**OSC Report on
Analysis of Disclosure, Agency Report, Whistleblower Comments,
and Comments of the Special Counsel**

OSC File No. DI-07-2724

Failed port plates due to design flaw (as found in the field – New Orleans, LA):

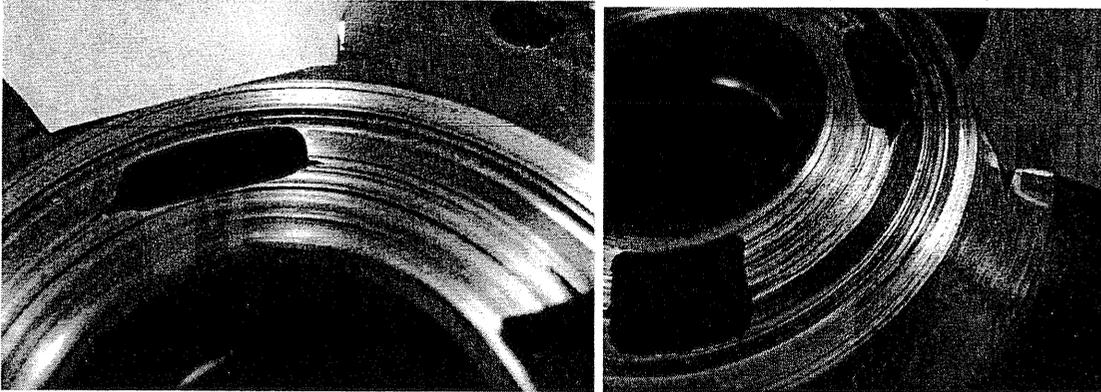
The following pictures of failed and failing hydraulic pumping equipment components are the direct result of the relaxation and elimination of certain factory testing requirements, which resulted in defective hydraulic pumping equipment being delivered to New Orleans. Contrary to what Colonel Bedey has stated, there was absolutely no plan to "fix the machinery while it was in place." (*See* previously cited documents).
